11 May 2018

**SH3 Mt Messenger Bypass  
Response to Applicant's Responses to S92 Information Requests**

Extract from plan showing landslide to north of Mt Messenger tunnel received by email 4 May 2018

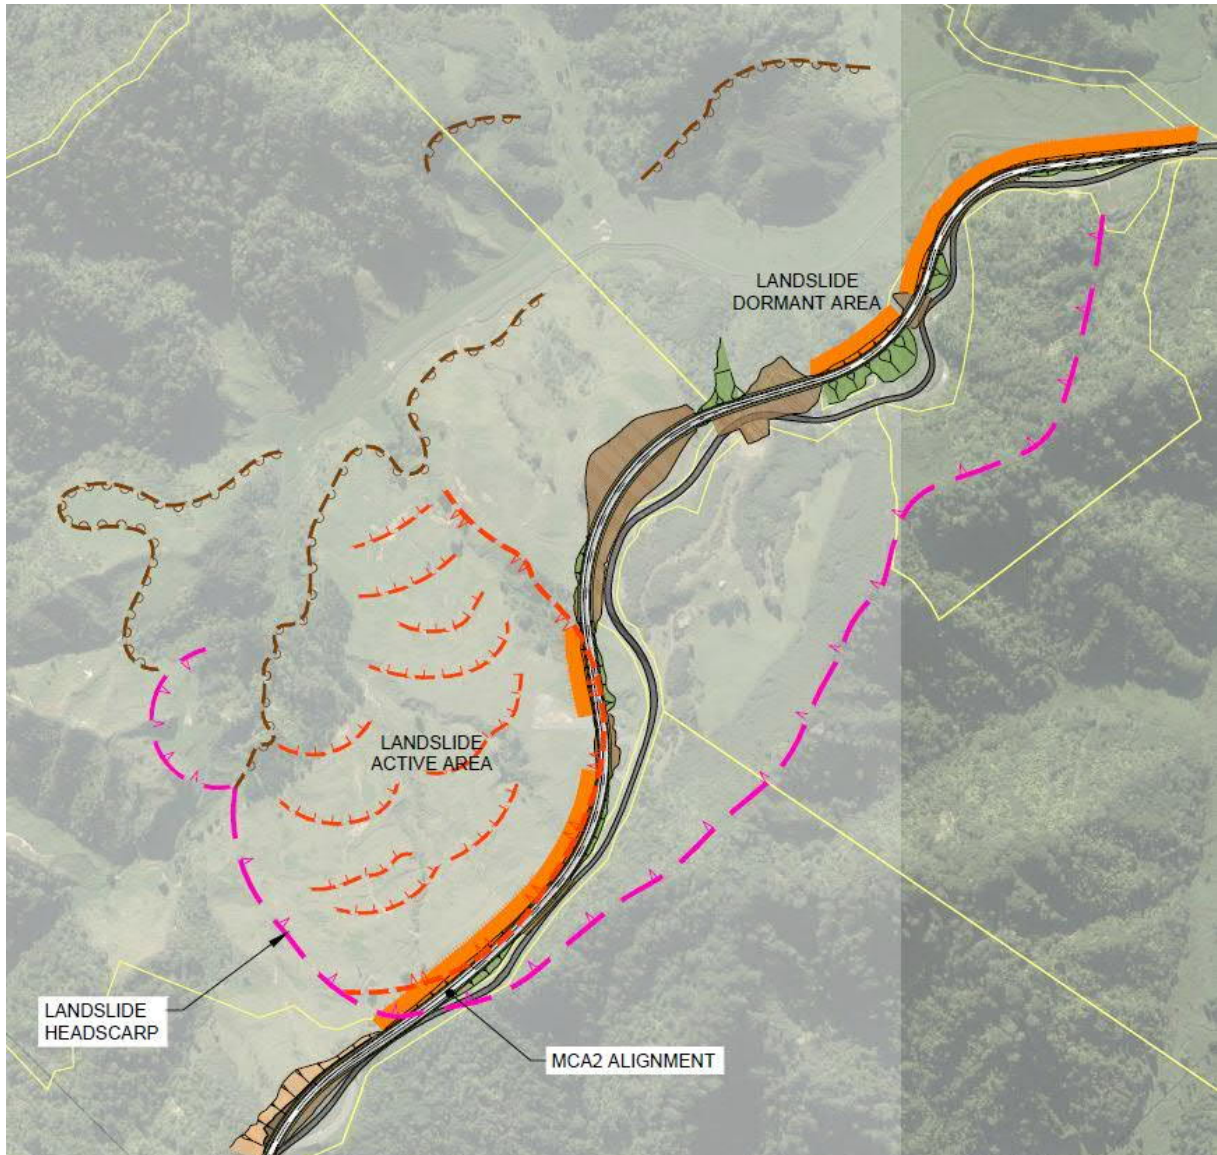
The applicant has provided little detail in the lodged documents with regard to the landslide, the findings of the geotechnical investigations in this area, or the proposed ground improvements required for Option Z. A plan received via email on 4 May 2018 shows the mapped extent of the landslide (see below). The northern part of the landslide is indicated to be dormant while the southern part is indicated to be active. The existing SH3 appears to traverse approximately 600m of this active landslide. However, it is understood that little maintenance has been required over this section.

During my site walkover of the active landslide on 9 May 2018, I saw little evidence of active movement in the vicinity of the existing SH3 or on the slopes above to the east. Hummocky ground, scarps and ponding water is evident to the west and I would anticipate ground improvement measures would be required for construction of embankments across this area.

I note that in the email correspondence received on 4 May 2018, the proposed design along this section of Option Z includes for a 1.5km long soldier piled retaining structure. The use of MSE structures may be a cheaper alternative to enable steeper embankment side slopes to be constructed on the sideling ground, although this would be subject to the findings of the geotechnical investigations carried out within the landslide area.

The presence of the landslide would certainly influence route selection in this area since it does pose a risk to resilience. Given the indicated significant cost of \$112M in constructing the retaining structure across this area, I would have thought consideration could be given to relaxing the design requirements for the proposed route along this section. A reduced design speed could allow the existing SH3 adjacent to the landslide, which includes a passing lane, to be retained. Alternatively, consideration could be given to minor improvements, including widening by retreat into the upslope area, again subject to satisfactory geotechnical investigations.
